# 首届成都市特色镇(街区)建设和川西林盘保护修复 规划设计方案征集(公众组)

First Solicitation of Planning and Design Proposals for the Construction of Chengdu's Featured Towns (Communities) and for the Conservation and Restoration of West Sichuan Linpan Rural Residence Complexes (Public Group)
澄清文件

Clarification Documents (2020年3月16日) (March 16, 2020)

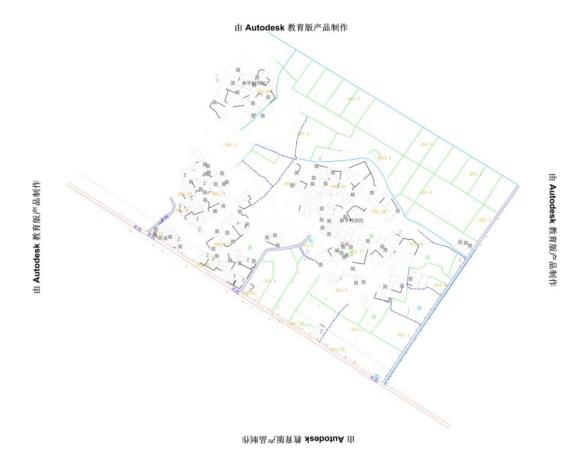
请问大邑县南岸美村林盘 CAD 中能展现此图中所包含信息?

Can the information contained in this map be displayed in the CAD of Nan'anmeicun

# Rural Residence Complex in Dayi County?

答: 地形图经过统一脱密处理,请按照提供的地形图进行设计。

Answer: The topographic map has been uniformly declassified. Please conduct design based on it.
